Service Note		
Product	Description:	Service note no.
Motofader64	Display error	795 10 1813

Filename: SNo_1818 Date: 06-02-2008

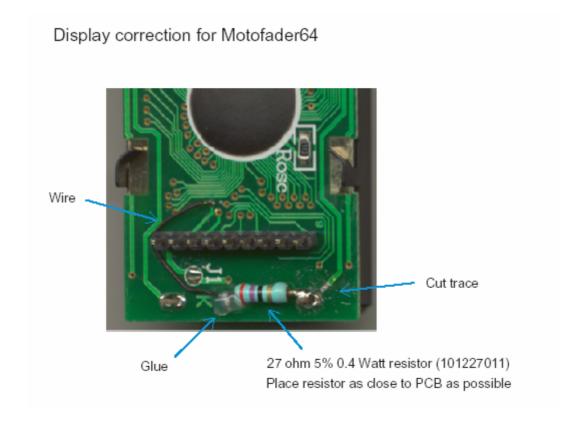
Symptoms: Due to possible overloading of the display backlight on the Motofader64, a current limiting resistor must be added. The modification is done on the display module according to attached description/drawing.

Remedy: Units received for service must be reworked with a new modified display. **Please scrap old display because of possible damage.** No change in schematics.
